Technical Service Bulletin

Topic	34 Oil leak at the transmission connector
Market area	United States 444 Volkswagen of America, Inc. (6444)
Brand	Audi
Transaction No.	2058875/2
Level	EH
Status	Released for publishing
Release date	Sep 5, 2025

Figure 1. Evidence of oil leak from the transmission control module seal.

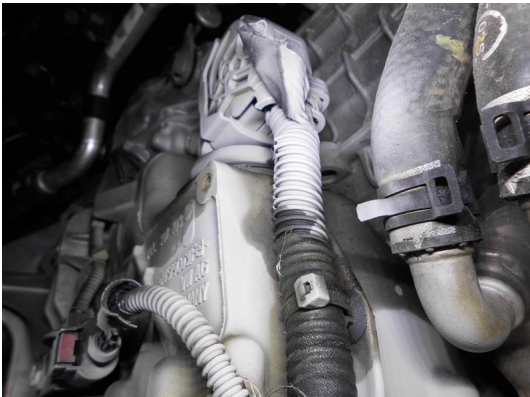
- Small traces of oil on the gearbox control unit from the seal under the gearbox connector.

1. Residual oil from the manufacturing of the transmission (lubrication of seal when installing the control module in transmission housing).
2. Overlap of seal on the transmission control module connector is not sufficient in all tolerances.

Figure 4. Oil accumulation -> oil is several mm high in the recess.

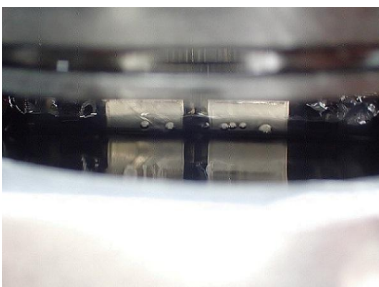
Oil accumulation (see Figure 4): assess whether oil is accumulating in the recess under the dust cap using workshop equipment (**there should be oil visible as shown in Figure 5**). If this is the case, attach a photo clearly showing the issue to the report. Then replace **the seal** of the gearbox control unit according to the Workshop Manual.

Fit **two new seals** as part of this repair (**part number: 0CK927523**). As shown below in Figure 5.

Figure 6. 2 seals fitted after performing the TSB.

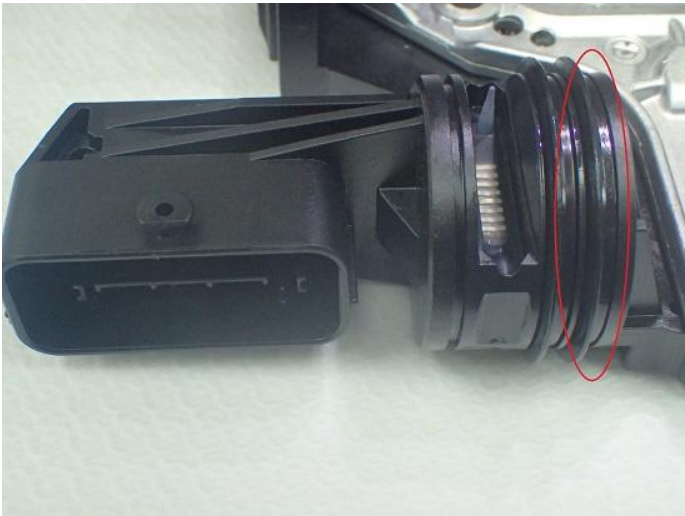
Original production state (Figure 5).

Figure 5. A seal fitted as standard
Modified state after performing TSB (Figure 6).

If oil traces are visible again, replace the seal of the gearbox control unit according to the Workshop Manual. Fit **two new seals** as part of this repair (**part number according to ETKA: 0CK927523**). As shown below in Figure 6.
